Florida Power

CORPORATION
Crystal River Unit 3
Docket No. 50-302
Operating License No. DPR-72

March 18, 1999
3F0399-01

Subject: License Amendment Request #235, Revision 1
Once Through Steam Generator Tube Surveillance Program,
Tube Repair Roll Process (TAC No. MA3592)

Figure 1: CR-3 OTSG Tube Repair Roll Process

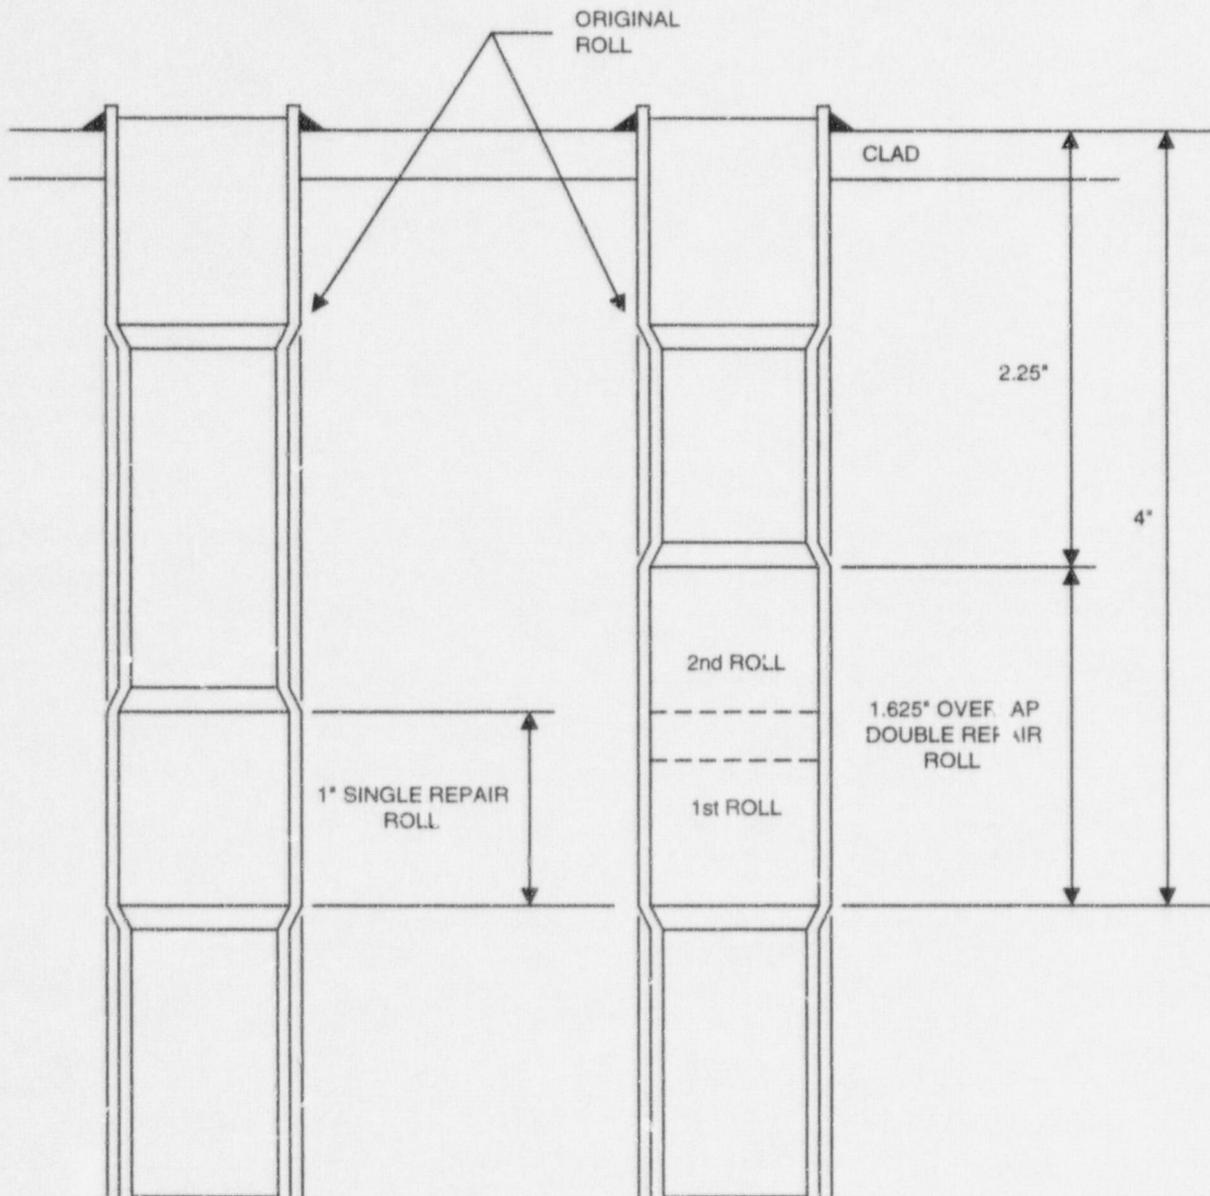
Currently, the approved repair methods for CR-3 are to plug or sleeve the defective tubes. This LAR proposes a method of repair for indications in the upper tubesheet by installing a repair roll. The repair roll creates a new pressure boundary by installing a repair roll joint below the existing tube-to-tubesheet joint containing tube defects in the upper tubesheet. The new pressure boundary joint will be the repair roll tube-to-tubesheet expansion joint that is closest to the secondary face of the tubesheet (See Figure 1).

3. Consistent with the conclusions of BAW-2342P, Revision 0, the double repair roll methodology (1.625 inch roll) will be implemented for tubes located at > 45 inches to < 56 inches radial position from the OTSG centerline. The double repair roll methodology, as detailed in BAW-2303P, Revision 3, will be applied with the exception that the double repair roll for CR-3 will not incorporate the original roll (See Figure 1).

4. The physical length of the expander will control the repair roll length. The repair roll will be located approximately 2.25 inches to 4 inches from the primary clad side of the upper tubesheet and will be situated entirely below the existing roll (there will be no overlap with the existing roll).
